Observation Report

Date:	July 17, 2017	Observation Date:	July 13, 2017
Architect:	Cannon Design	Location:	Webster ISB - General
Attn:	Kelvin Patel	Observer:	Mike Nolte (WTA)
Gen. Contr.:	Paric	M/E/P/F Contr.:	Varies
File:	Webster University Interdisciplinary Science Bldg. WT 14127.01 (7)	c:	Jason Szachnieski & Devin Gates (Paric)

Level 3 - Mechanical Observations

Name	Webster ISB Level 3 Mechanical Punch
Description	Issues with all of the fields, plus optional attachments, custom properties, signatures and comments
Report run on	17 Jul 2017 11:19 AM
Number of pages	34 including this summary page

Attached Images for ID 001164

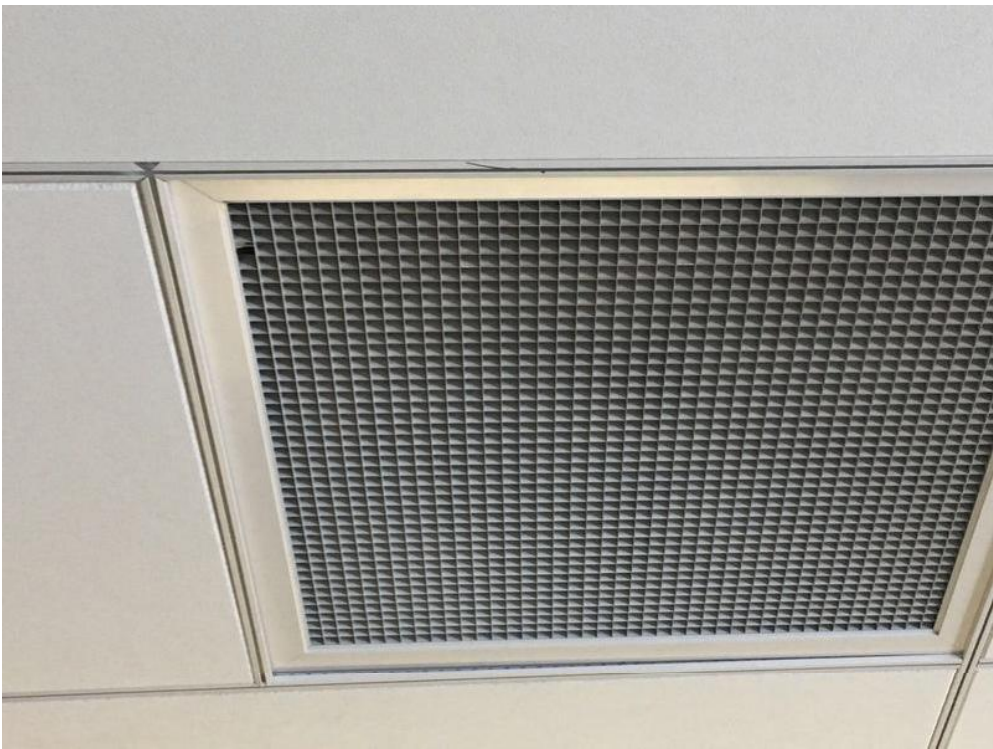
Supply diffuser plaque is at an angle. Adjust as required

Attached Images for ID 001175

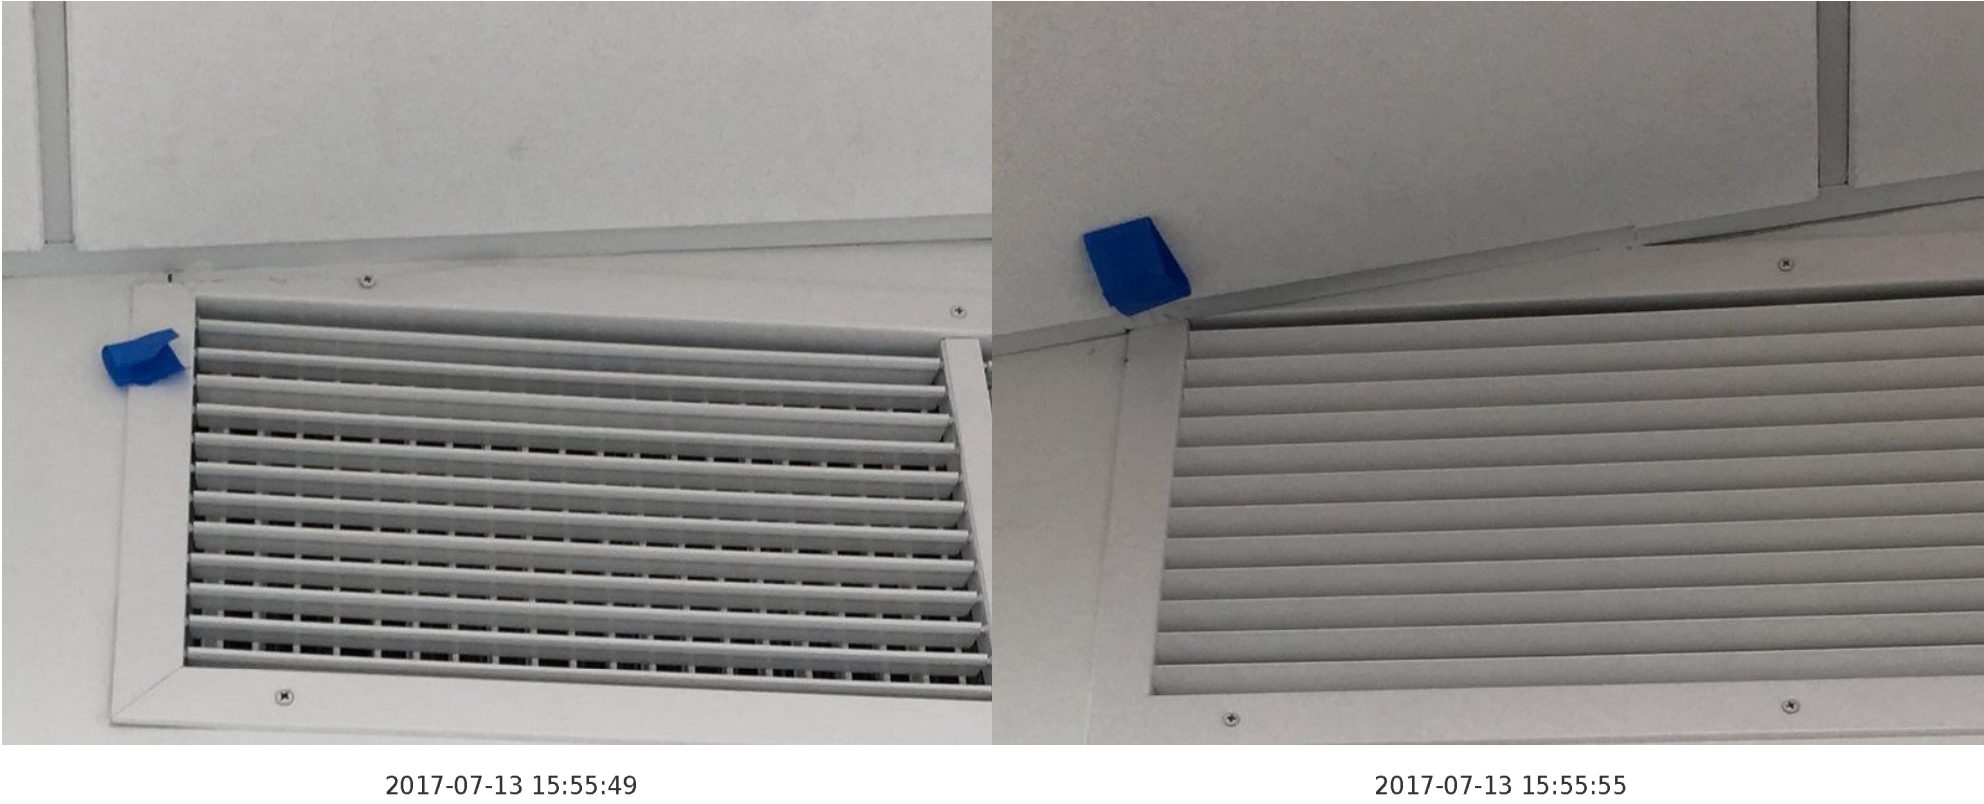
Description
342: Touch up field fabricated edges of sidewall grills as required for a smooth looking appearance.

Comments for ID 001175
Alex Chambers (achambers@iconmech.com) 17 Jul 2017 8:50 AM Per Paric direction, diffusers were cut to accommodate ceiling construction.
